**ADDENDUM NO. 2
CITY OF PEORIA
Combined Sewer Overflow Control Project – Year 1
January 25, 2022**

Re: Addendum for Bid Package, **Combined Sewer Overflow Control Project – Year 1**, Peoria, IL

This Addendum includes the following revisions listed below.

PAVEMENT PATCHING (SPECIAL) DETAIL

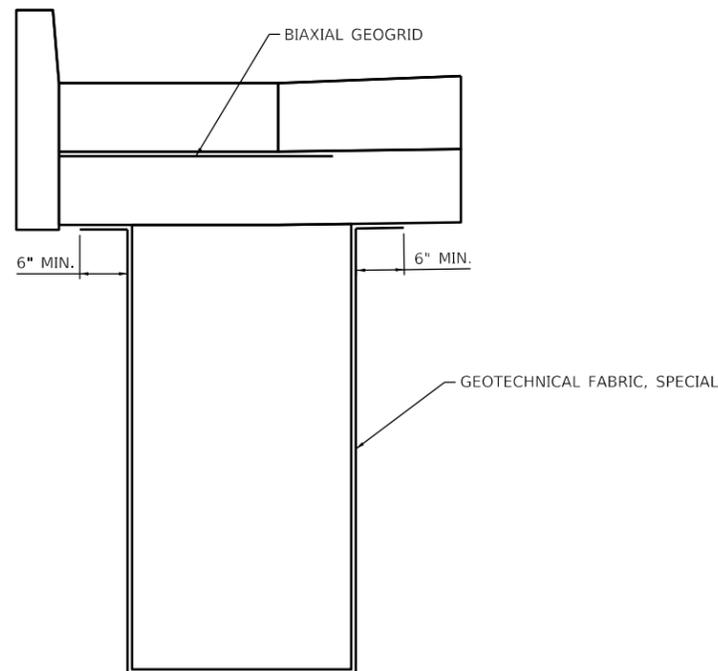
1. Sheet 3
 - a. Revised Bituminous Mixture Table to remove binder course requirements since this is no longer applicable
2. Sheets 4-7
 - a. Added specialty items
3. Sheet 85
 - a. Revised Pavement Patching (Special) Detail.
